INTERNAL MEMORANDUM

Our Ref.: 25/0135

OBSERVATIONS BY THE ENGINEERING AND HIGHWAYS DIVISION IN RESPECT OF DEVELOPMENT AFFECTING EXISTING OR PROPOSED PUBLICLY MAINTAINED HIGHWAY

The proposed application is for the change of use of part of a valet centre to provide a gym at

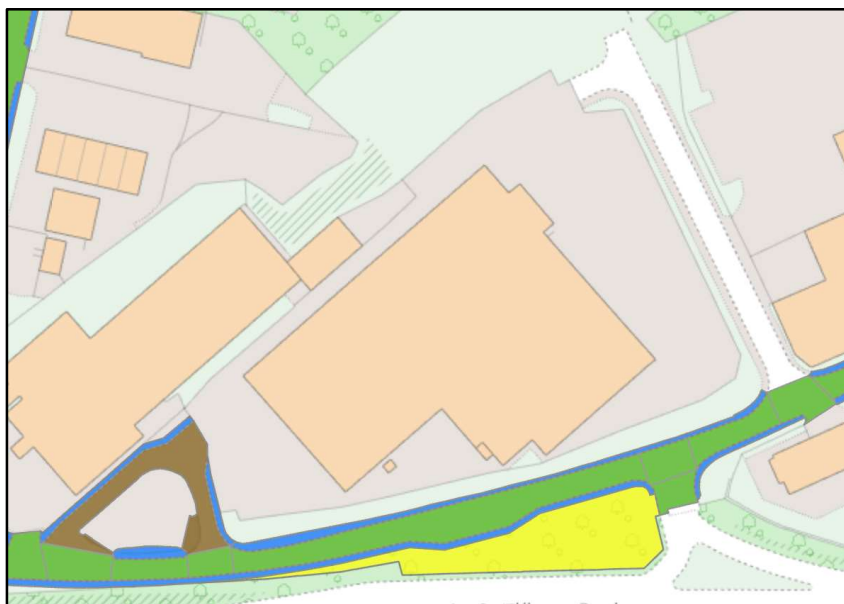
The unnamed road along the application buildings frontage is non-adopted and the road to access the northeast car park is also non-adopted, however the small road to the southwest to access the car park is adopted highway and restricted to 20mph. See below image that shows the highway adoption record.
